**TOWN OF MOUNTAIN VILLAGE
DESIGN REVIEW BOARD REGULAR MEETING
THURSDAY FEBRUARY 5, 2015, 10:00 AM
2nd FLOOR CONFERENCE ROOM, MOUNTAIN VILLAGE TOWN HALL
455 MOUNTAIN VILLAGE BLVD, MOUNTAIN VILLAGE, COLORADO
AGENDA
REVISED**

**COMMUNITY DEVELOPMENT DEPARTMENT
PLANNING DIVISION**

LANDSCAPE PLAN

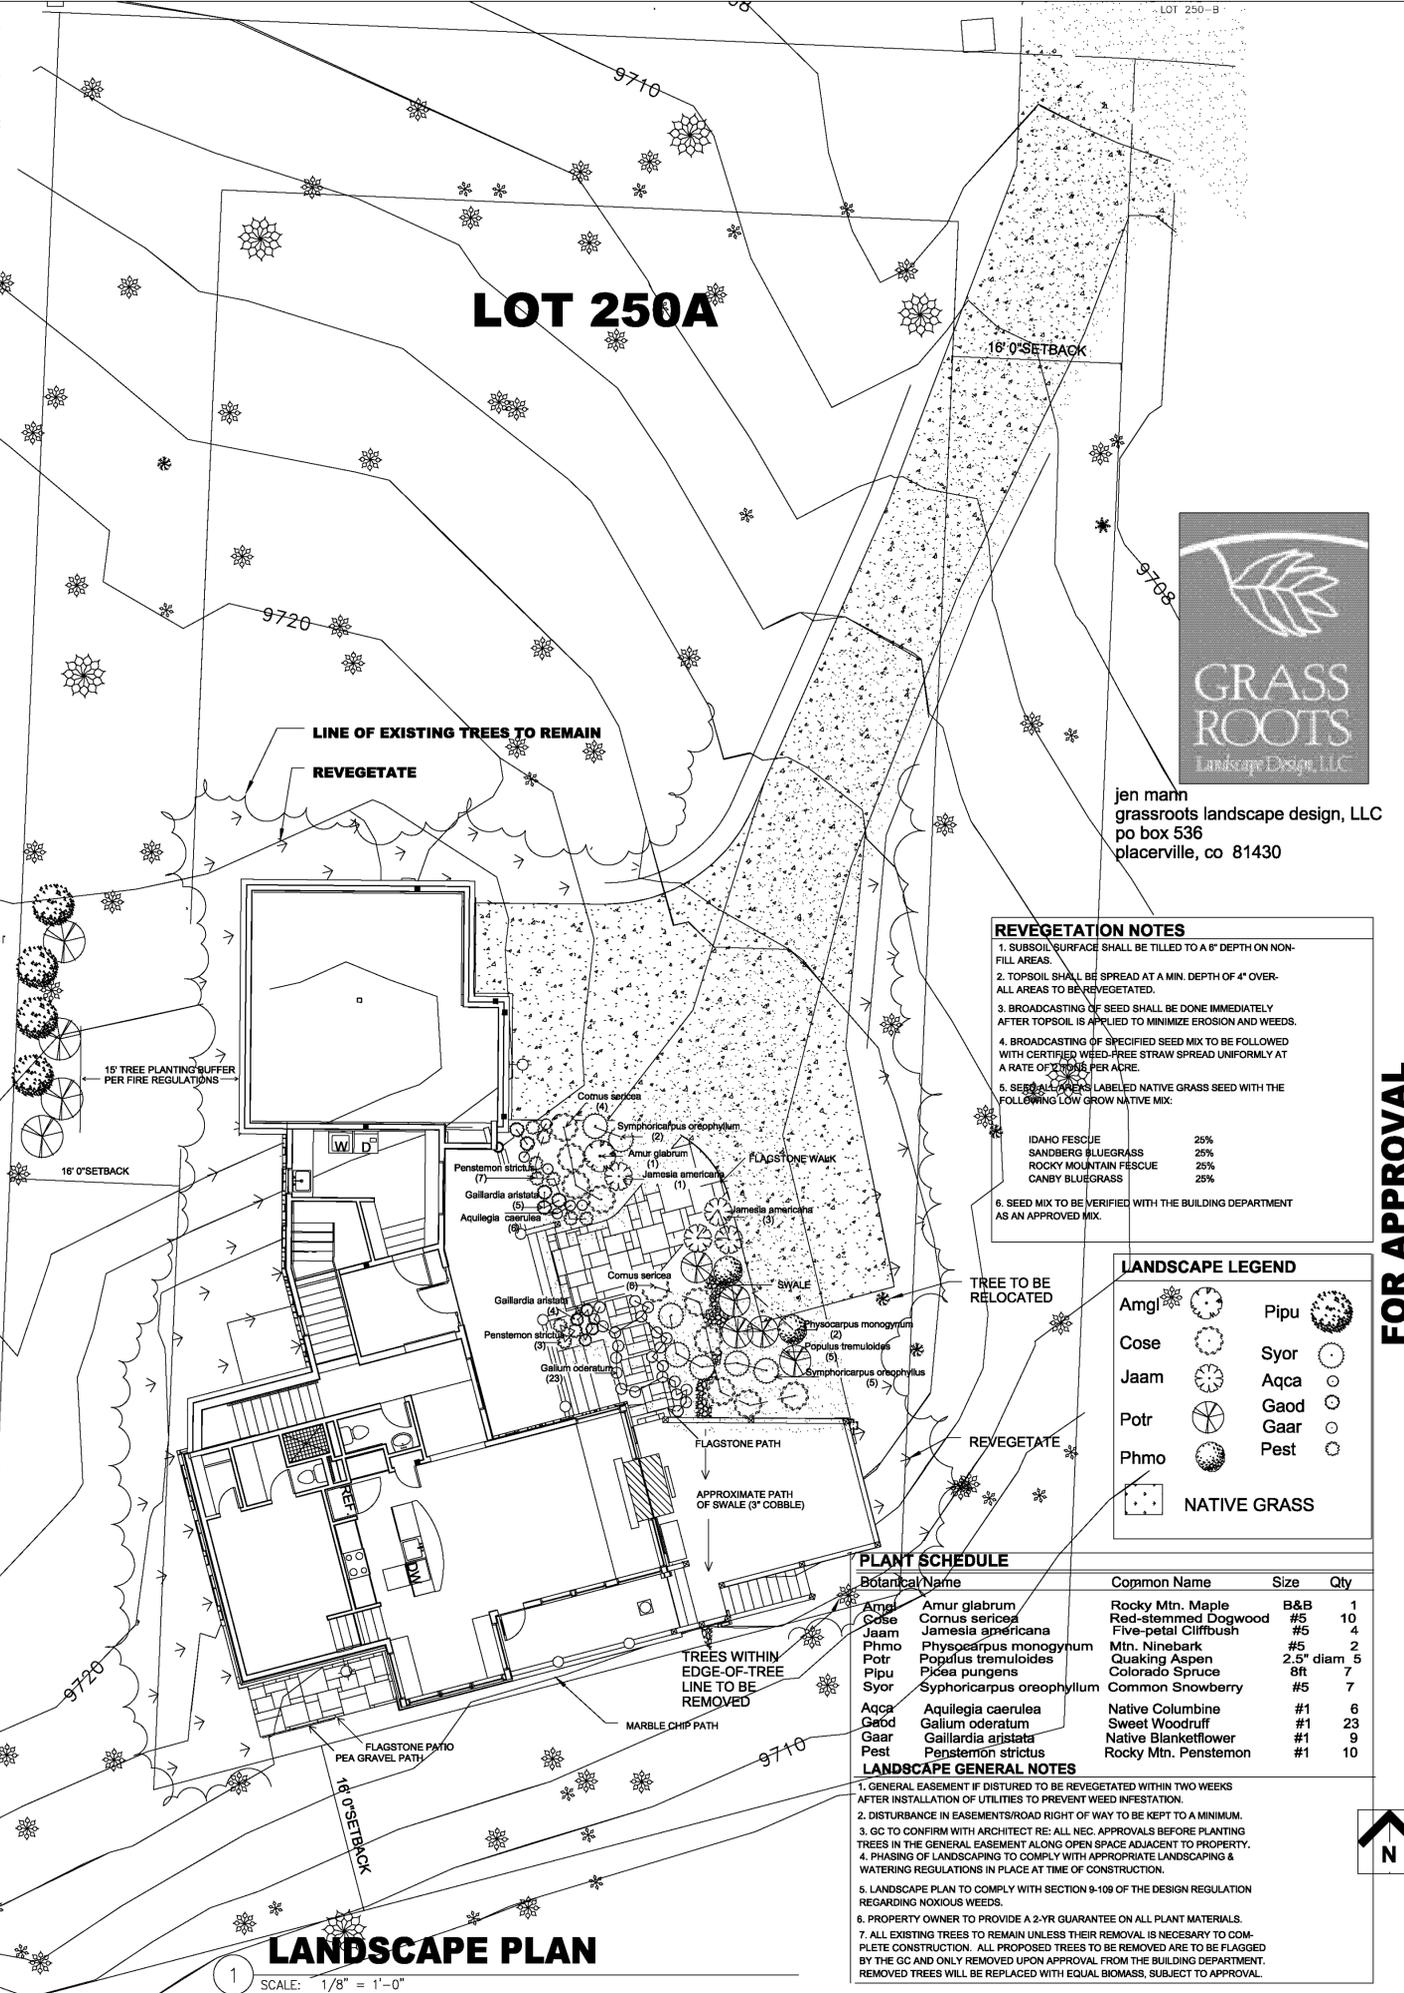
The landscaping plan will have to be revised to include notation on the following required Landscaping Regulations prior to issuing a development permit:

1. Section 17.5.9(C)(4) requires certain elements in the irrigation system, such as a backflow preventer, interior and exterior drain valves, and a master control valve. The landscaping plan will have to be revised to include notations on the required efficient water use design elements.
2. Section 17.5.9(C)(5) requires certain measures to ensure soil protection and erosion control.

3. Section 17.5.9(C)(6) establishes minimum planting size requirements that are not met in the plant schedule, such as the need to provide 30% of the evergreen trees at a size of 10 feet tall or larger; the need to have a diversity of tree plantings with at least 40% of the trees on the landscaping plan not typically found in the town, such as lodgepole pine, white pine, ponderosa pine provided such trees fit with the life zone and the site's microclimate. The quantity of deciduous and evergreen trees also needs to match the numbers shown on the plan. The minimum quality of the nursing stock also has to meet the American standard for nursery stock. Planting schedule notes 3 needs to be removed since it does not relate to any requirement of the CDC, and note 5 needs to include the correct CDC reference concerning weed control. The native grass seed mix also needs to be specified consistent with the Landscaping Regulations.

4. The landscaping plan should be revised to have the note, schedules and legends to where they are not overlapping the plan or existing conditions as it is difficult to read certain areas of overlap.

5. The location of the gas and electric meters needs to be shown on the site and landscaping plans to ensure proper screening.

6. Prior to issuing a development permit, the landscaping plan shall be revised to address the detailed list of needed revisions outlined in the staff memo of record dated January 29, 2015.

BUILDING ELEVATIONS

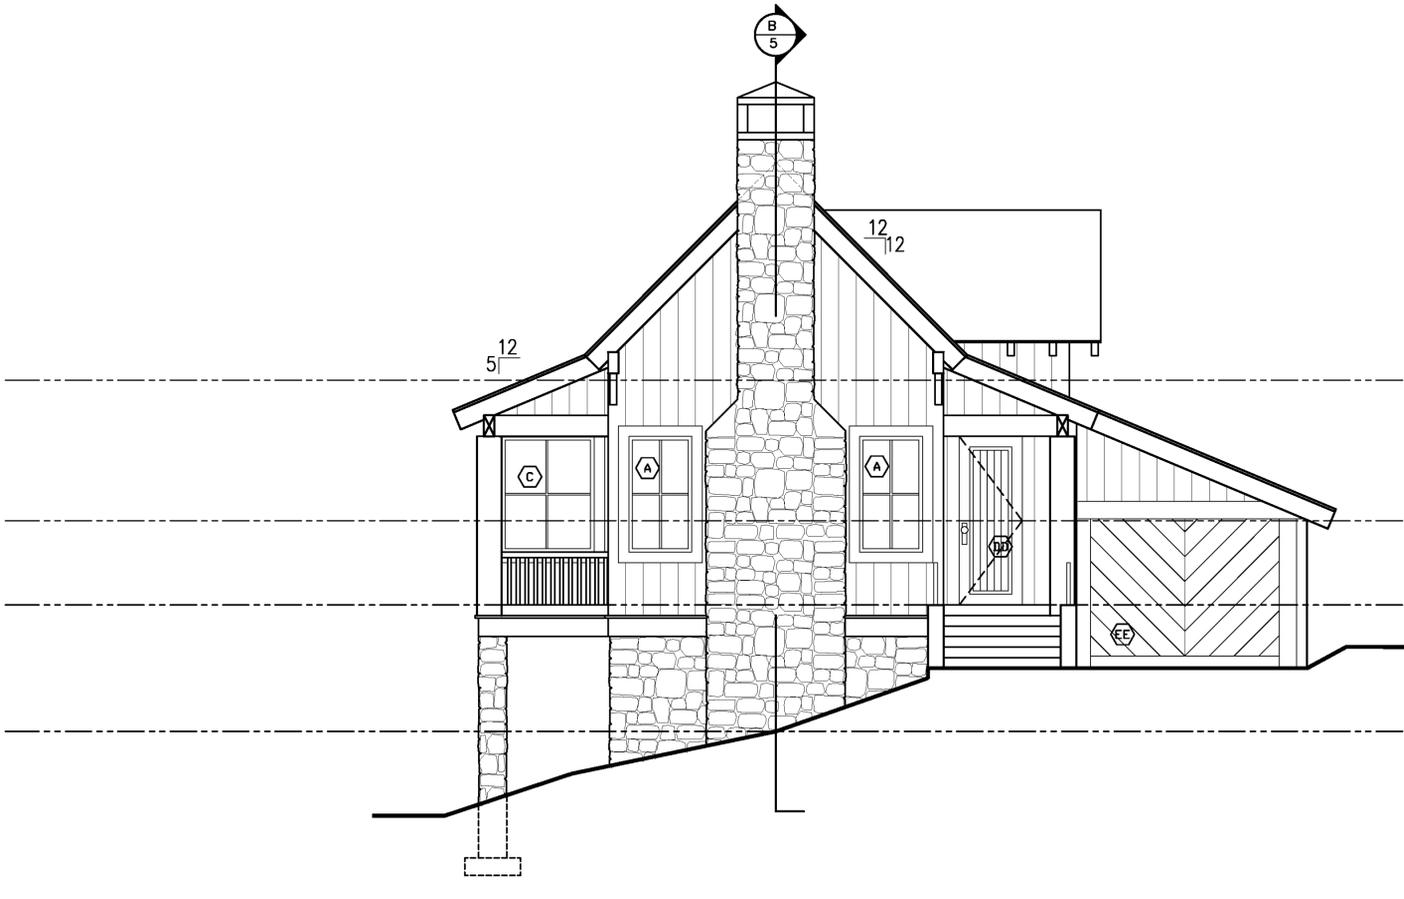
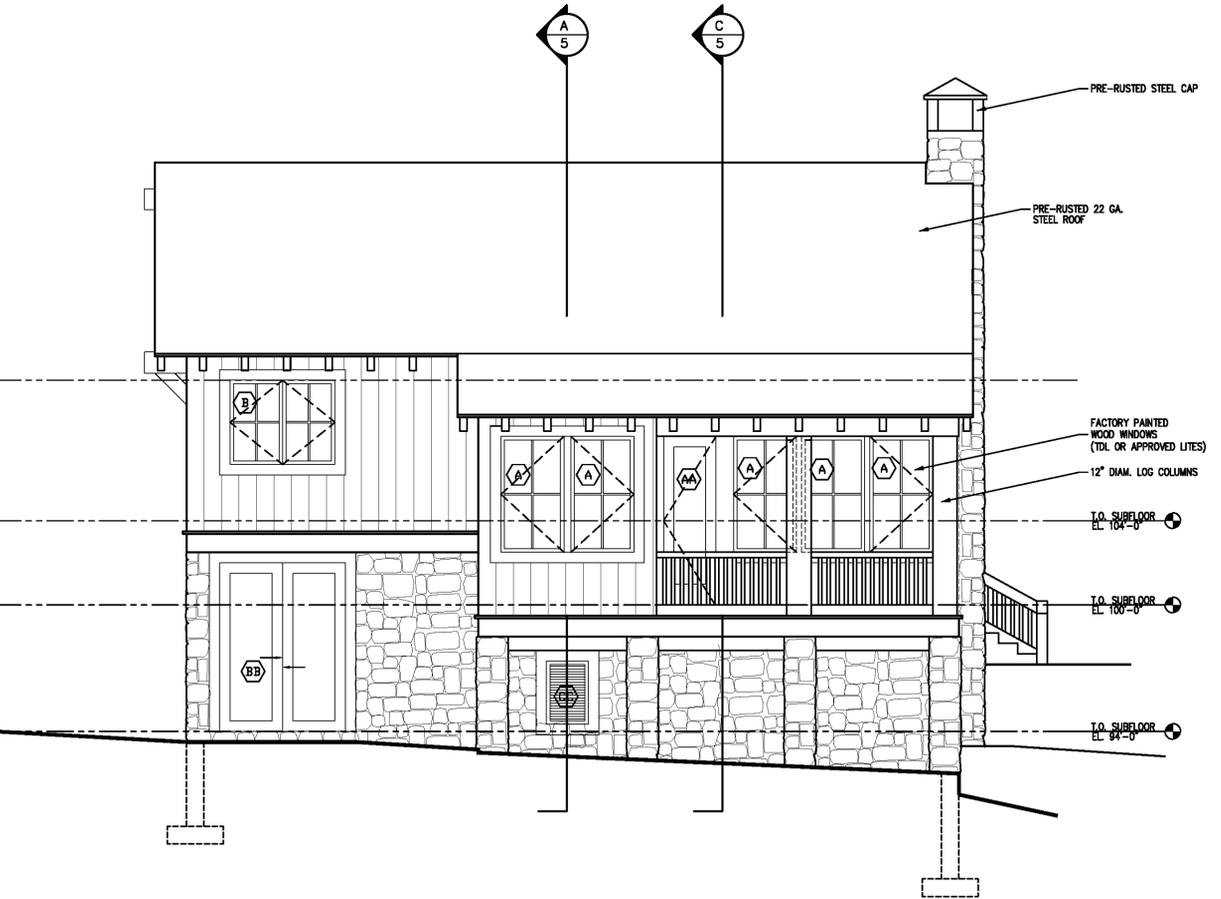
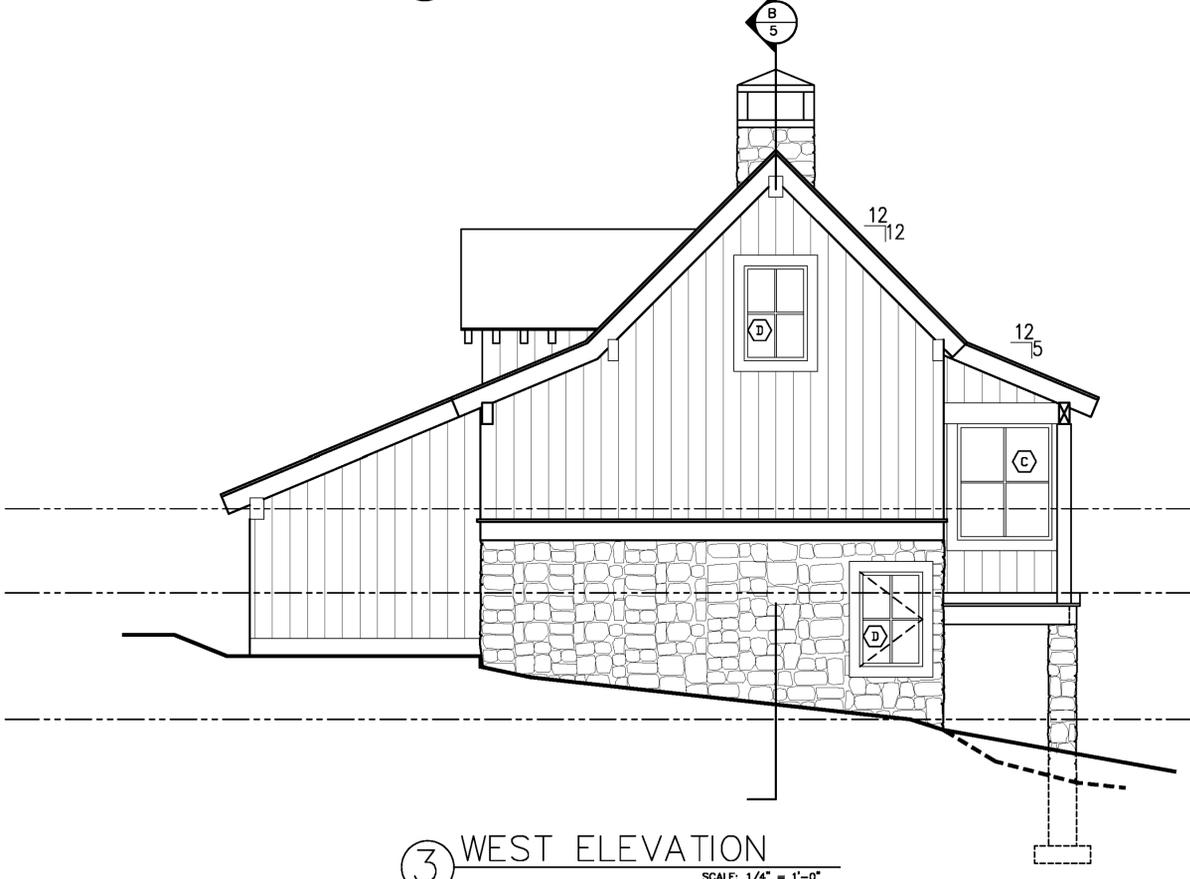
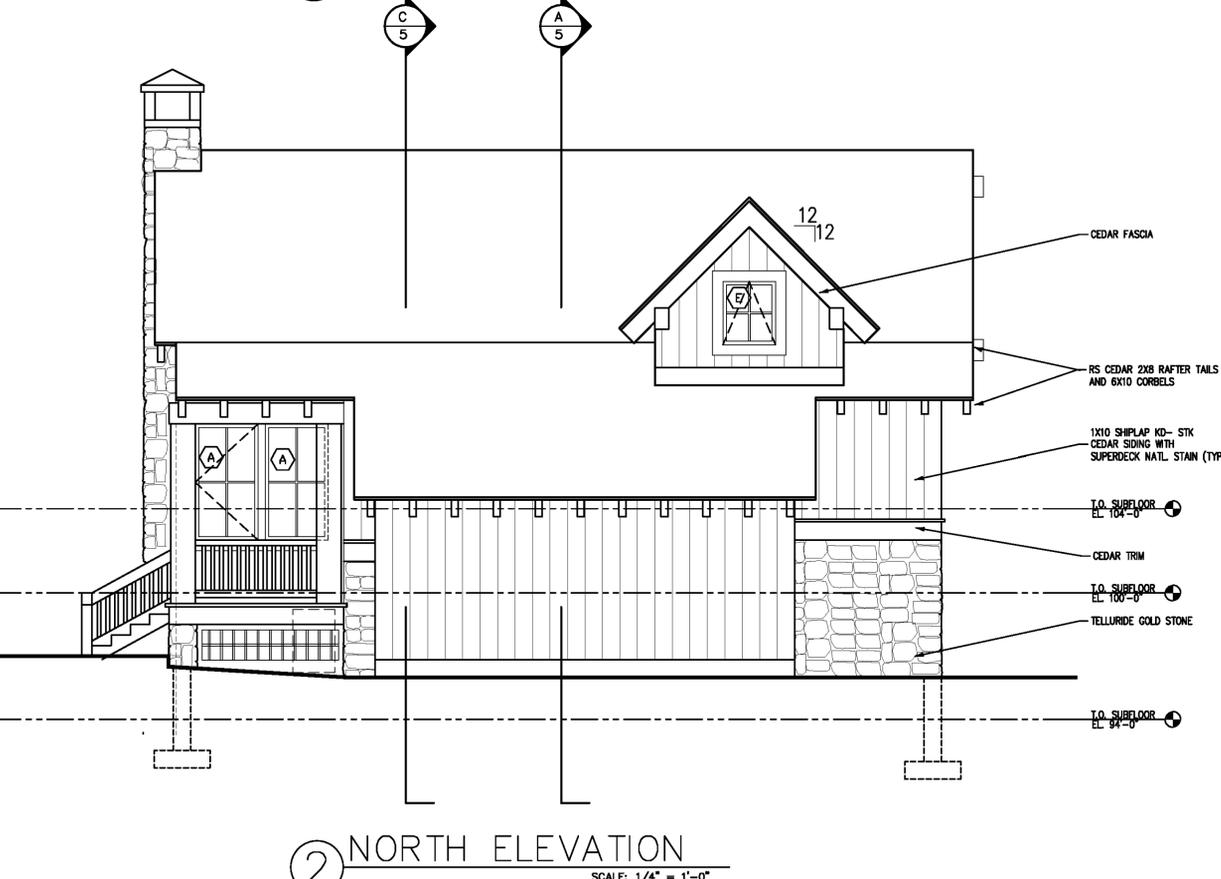
CDC Section 17.5.6(H)(1) states, for single-family development, doors and entryways shall use handcrafted materials whenever possible. The primary entrance doorways shall establish interest, variety and character and shall be reviewed by the review authority on an individual basis. The applicant will provide proposed design for the new entry and garage doors to the DRB at the meeting.

The exterior color needs to be specified, with the applicant indicating the intent is to match the existing color of the home as shown in the plan set photos.

2. Prior to issuing a development permit, the Applicant shall revise the building elevations to include details on the design of the entry and garage doors consistent with CDC Section 17.5.6(H)(1).

4. Prior to issuing a development permit, the proposed exterior color will be clearly marked on the plan set.
5. Prior to issuing a development permit, parking space #3 shall be moved adjacent to parking space # 4.
